## Duquesne Light

July 6, 1983

Reference: Beaver Valley Power Station, Unit No. 1  
Docket No. 50-334, License No. DPR-66  
N-1 Loop Operation

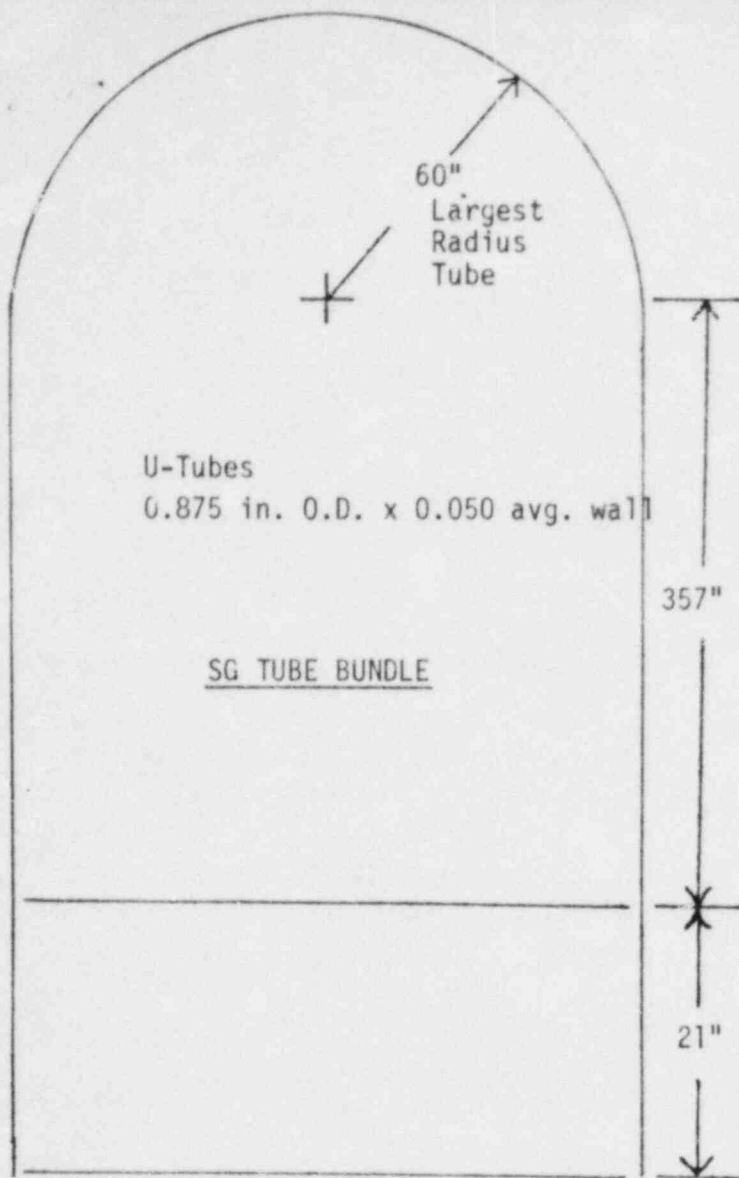
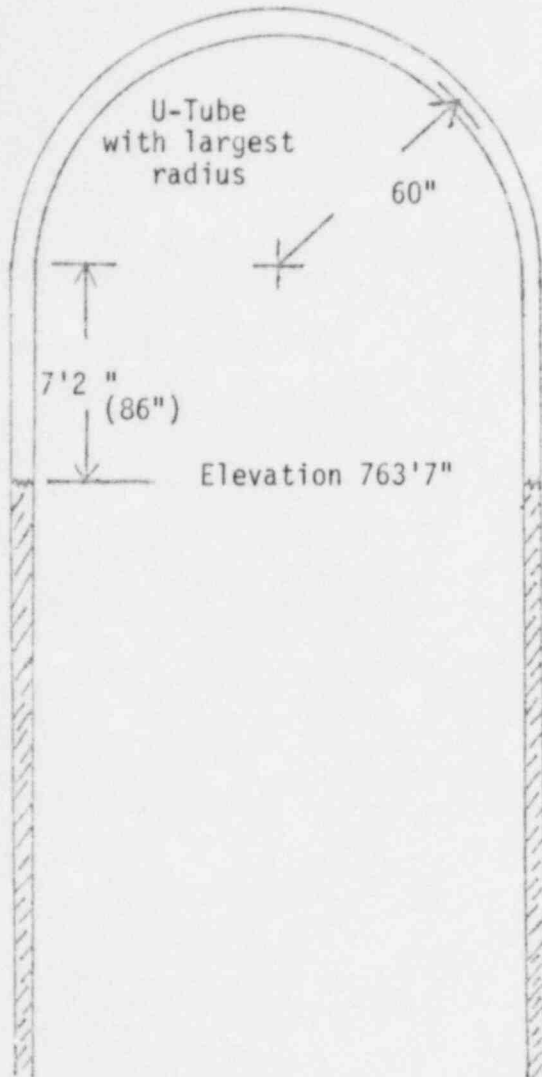
3. Due to the potential for water hammer, what means will be employed to insure the isolated loop is full?

A visual check on an installed pressure instrument to check that pressure is greater than 15 psig. This will ensure the steam generator tubes are substantially full (see Attachment I)

1 Elevation at top of tube bundle = 739'3" + 36'6" = 775'9"

2 Elevation of RTD manifold B  
= 733'6  $\frac{15}{16}$ "

3 Elevation difference  
1 - 2 = 775'9" - 733'7"  
= 42'2"

Pressure of 42'2" water column @ 100°F

$$\begin{aligned}
 p &= \rho gh \\
 &= 62.0 \frac{\text{lb}_m}{\text{ft}^3} \left[ \frac{32.2 \frac{\text{ft}}{\text{sec}^2}}{32.2 \frac{\text{ft} \cdot \text{lb}_m}{\text{lb}_f \cdot \text{sec}^2}} \right] 42.167 \text{ ft} \left[ \frac{1 \text{ ft}^2}{144 \text{ in}^2} \right] \\
 &= 18.2 \text{ lb}_f/\text{in}^2
 \end{aligned}$$

When tubes are filled to elevation 763'7" (corresponds to 30' water column), the largest radius tube will have an unfilled volume (calculated below).
